PERMIT

SEWAGE DISPOSAL SYSTEM
HOWARD COUNTY HEALTH DEPARTMENT
BUREAU OF ENVIRONMENTAL HEALTH
410-313-2640

UBDIVISION Monticello LOT NUMBER 32 ADDRESS 14320 Fox Creek Court

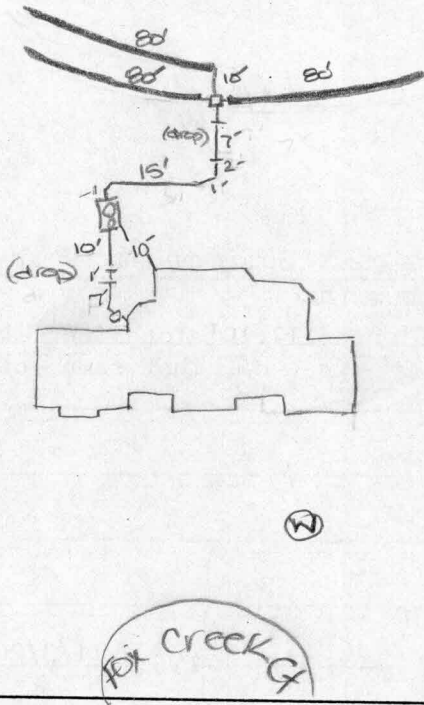
PRE-CONSTRUCTION INSPECTION: 2/20/01 layout check OK - SDA started. DKC

INSPECTION COMMENTS: 2/21/01 A.M. First two trenches OK - need to correct pipe from house to s.t. (10' prior to tank must be 1-2% slope), OK

2/21/01 P.M. Final inspection - OK to cover all septic work. DKC
